# REQUEST FOR EXCEPTION TO RAPID CITY DESIGN STANDARD / CRITERIA / REGULATIONS

PROJECT Lot 21 of Block 4, Auburn Hills Sub	division
DATE: 2/3/17 SUBMITTED BY: (Include Name, Company Name, Email Address & Phone Number)	Sperlich Consulting, Inc.
PIN #:	info@sperlichconsulting.com, (605)721-4040
<del></del>	of the NW1/4 Section 13, T2N, R7E, B.H.M., Rapid City,
Pennington County, South Dakota	
EXCEPTION REQUESTED: SECTION 3.5.4	I, 3.5.5, 2.0 STD / CRITERIA / REG Criteria
	ruct public water and sewer mains within Haines Avenue.  k, handicap ramps, and street light conduit within Haines Avenue.
existing quarry site and should not require the extension of public wa	Lot 21 is the extent of current City limits. North of proposed Lot 21 is an ater and sewer mains. Any development on Lot 21 will service off of existing

Re: Exception File No. 17EX048

Request for Exception to waive the requirement to provide additional pavement width, curb, gutter, sidewalk, handicap ramps, street light conduit, water and sewer in Haines Avenue. City File # 17EX048, Related Files 16PL092

Exception 17EX048 – Auburn Hills Sub, Haines Ave March 6, 2017 Page 2

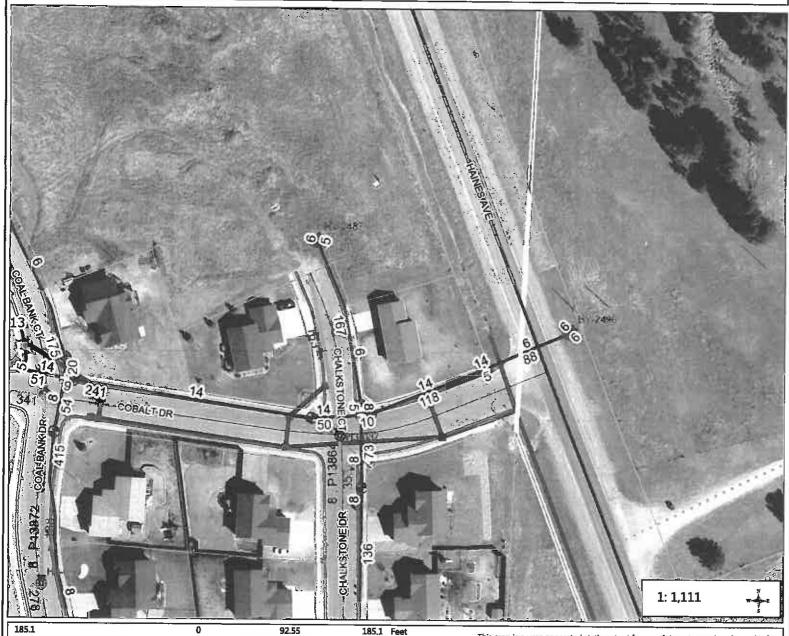
The Request for Exception to the City of Rapid City Infrastructure Design Criteria Manual (IDCM) to waive the requirement to provide additional pavement width, curb, gutter, sidewalk, handicap ramps, street light conduit and a second dual water main in Haines Avenue is approved.

The Request for Exception to the City of Rapid City IDCM to waive the requirement to provide one water main and a sewer main in Haines Avenue is denied.

Haines Avenue is adjacent to the proposed plat for approximately 475'. Pennington County rebuilt Haines Avenue adjacent to the proposed plat within the last 10 year to the rural pavement section that it is today, and void of street lights or sidewalks. Additional street improvements within Haines Avenue do not appear to be warranted at this time. It should be noted that an exception can be granted for handicap ramps at intersections, however exceptions to sidewalk improvements cannot be granted. A variance to Rapid City Municipal Code 12.08.060 is required to waive sidewalk improvements in adjacent right of way associated with a building permit. A variance can be deterred until a building permit is anticipated to come forward to the City.

The City has master plans showing the extension of a water main and a sewer main within this area of Haines Avenue to serve future development to the north. The IDCM 3.5.4 and 3.5.5 states that water and sewer mains shall be extended across the full frontage of each parcel to be served, thus the proposed plat requires the installation of mains in the adjacent Haines Avenue. The extension of mains across the full frontage of the parcel allows the utilities to be available to neighboring properties. The proposed lot within Auburn Hills Subdivision is provided access and utilities through Coal Bank Drive and Chalkstone Drive, however, the improvements in adjacent roadways are required with the platting process even if they aren't needed to specifically serve the development. A 12" water main is master planned in the north/east boulevard of the road and an 8" sewer main also is master planned. A dual water main is not needed at this time.
